PART - GROUP CHANGE NOTIFICATION				Bulletin no	2002-03	Date	30.07.2002
	Prepared by	Yaşar Ceylan			Signature			
	Approved by							
	Copy to	TH-YPLB	✓	ÇMİ-MTK1	✓	ÇMİ-ÜPB		Other
ÇMİ-KGB		✓	ÇMİ-MTK2	✓	ÇMİ-MÜT		Other

Issue	Water Diverting System Change
-------	-------------------------------

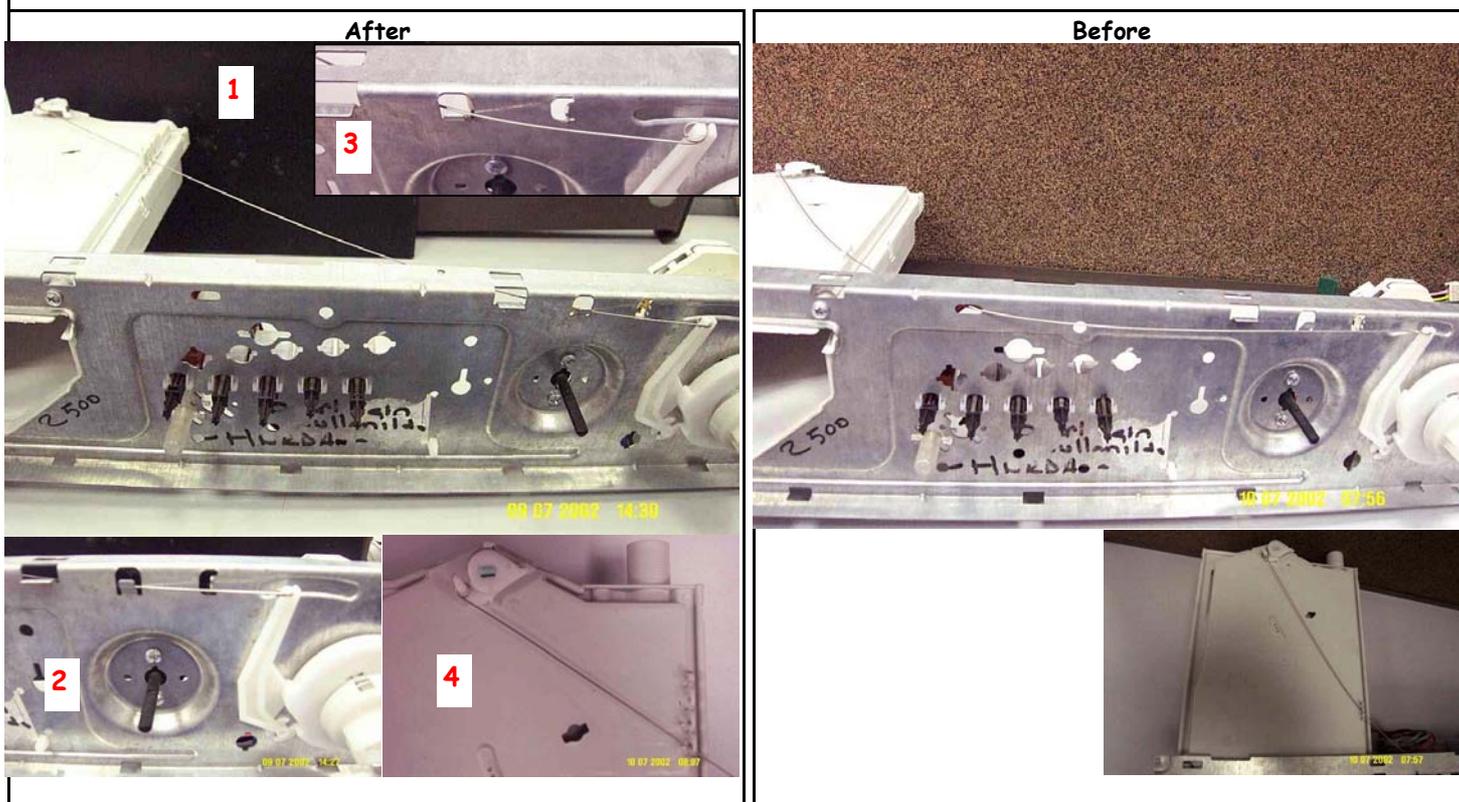
Explanation
 In order to use a new part in our new projects we need extra area on the detergent box cover. For this reason we had to modify the cover. Because of this change the route and length of the Movement transmission wire also had been changed. The new length of the wire is $(477 \pm 0,5 \text{ mm})$. The new route of the wire is shown in figure 1 and 3. The wire should be located between the first two clips (figure 4) and the wire has to be fixed to the cam follower as shown in figure 2 and 3.

Ref	New part(s)			Old Part(s)			Code
	Part name	Stock number	Rev	Part name	Stock number	Rev	
110	Movement transmission wire	28 0902 01 00	A	Movement transmission wire	28 0901 01 00	C	B2
